UNITED STATES OF AMERICA
NUCLEAR REGULATORY COMMISSION

In the Matter of)
)
Duke Energy Florida, LLC) Docket Nos. 52-029 and 52-030
)
(Levy Nuclear Plant, Units 1 and 2))

DUKE ENERGY FLORIDA’S RESPONSES TO PRE-HEARING QUESTIONS

Downspout Screen Location

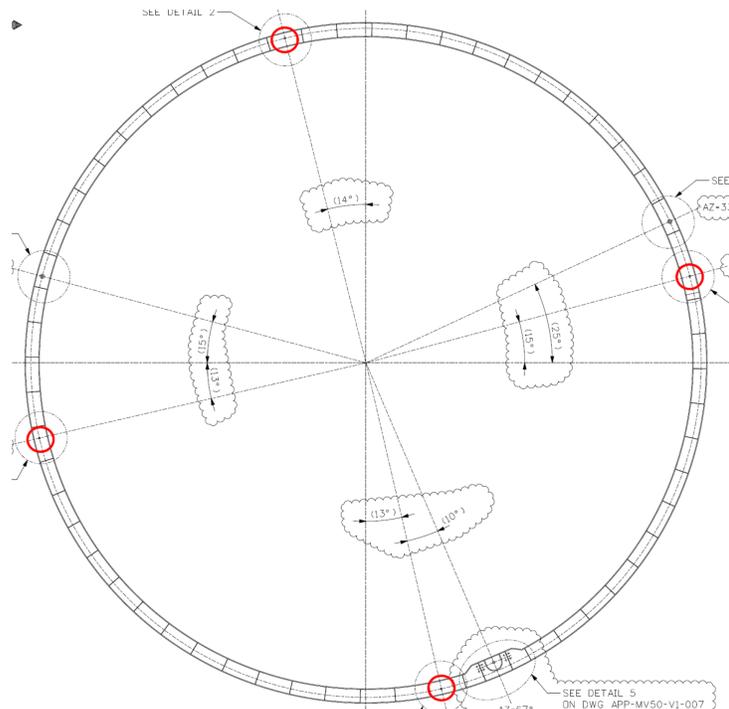
Question 25. As a part of LNP DEP 3.2-1 and LNP DEP 6.3-1, the applicant describes the addition of protective screens to the downspouts to protect the passive residual heat removal heat exchanger (PRHR HX) from debris. Has the applicant or the Staff investigated whether the screens could be subject to clogging phenomena similar to what is considered by Generic Safety Issue 191 (GSI-191)? Has the applicant performed any analysis to determine how long the PRHR HX can remain functional with degraded return flow to the in-containment refueling water storage tank (IRWST)?

When designing the downspout system and screens which interface with the polar crane girder (PCG) and the internal stiffener, plugging of one of the downspout screens was taken into

consideration to meet single failure criteria. Design calculations support downspout sizing and screen sizing considering a single failure (plugging of a downspout screen), and flowrates are shown to support adequate pressure drop to avoid overflowing at any one location while avoiding the potential for flashing in the system piping.

Related to their location in containment, the polar crane girder and internal stiffener are not easily accessible and are not located in high traffic areas which may result in potential cleanliness issues that may plug any of the screens. The four screens added at the polar crane girder and internal stiffener are evenly spaced around containment to provide separation between each of the downspout connections. The figure below provides detail as to the location of the screens at the internal stiffener elevation.

Figure: Polar Crane Rail and Dam

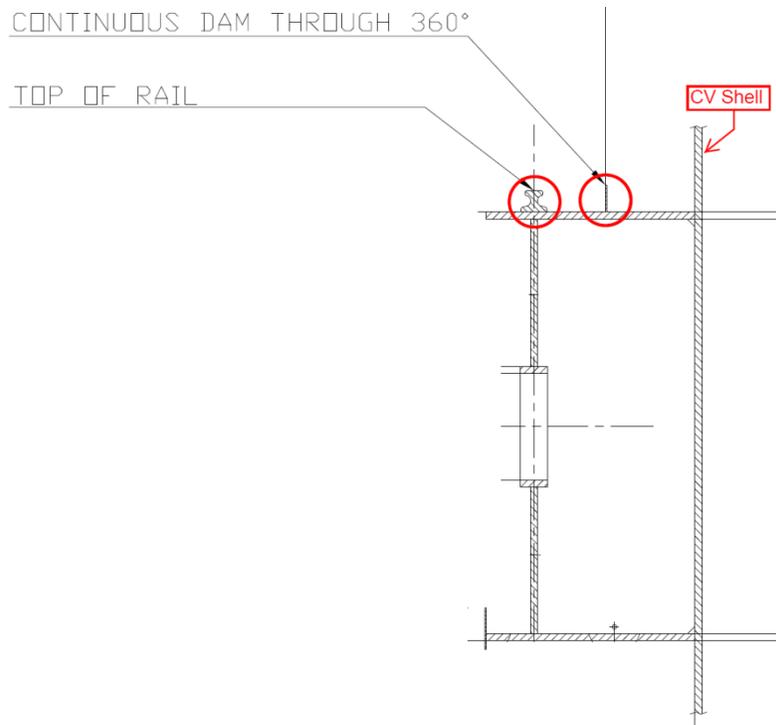
Question 27. As part of the exemption for DEP 3.2-1 related to the passive core cooling system (PXS) containment condensate return, Technical Specification (TS) Surveillance Requirement 3.5.4.7 was added to require a visual inspection of the IRWST gutter and downspout screens to verify that the return flow to the IRWST will not be restricted by debris.

The Staff's technical evaluation of the exemption request and departure states, "Condensate return is one of the primary factors influencing the performance of the PRHR HX." The Staff further explains that the PXS downspout piping network was added at the polar crane girder and stiffener with four specific collection points located on both the upper portion and the

The position of the polar crane on the girder has no impact to the rate of condensate return. The rail that the polar crane rides on is located several feet from the containment vessel shell, and goes around the entire circumference of containment. The dam which was added on the polar crane girder is located between the containment vessel shell and the polar crane girder rail. Therefore, any condensation which occurs on the containment vessel shell and travels down the shell to the polar crane girder collection location will be separated by the dam from any interaction with the polar crane itself. Any condensation which occurs on the polar crane and/or the polar crane structure that spans from one side of containment to the other will not be captured by the gutter system. This is accurately modelled in WGOTHIC as a heat sink, and therefore no credit is taken for capturing this lost condensation. The Figure below shows an image of the continuous dam and also the rail for the polar crane.

In the Figure above, the polar crane rail and the continuous dam are circled. The containment vessel shell is pictured at the right of the figure. Therefore, based on the orientation of the polar crane circumferential dam, there is no need for a Technical Specification or Surveillance Requirement restricting the polar crane bridge position on the girder.
